Site Access

Road Safety Audit Stage 1

on behalf of Woods Hardwick

Land off Bullens Green Lane, Colney Heath, Hertfordshire Site Access

2.1 PROBLEM

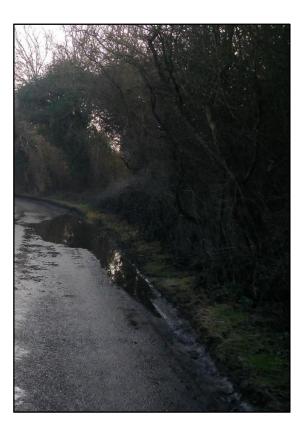
Location - Bullens Green Lane

Summary: Loss of control type collisions – all road users

Bullens Green Lane is prone to flooding and standing water at this location can cause loss of control type collisions for all road users.

RECOMMENDATION

Levels of the carriageway along Bullens Green Lane need to be checked and additional drainage introduced as required.
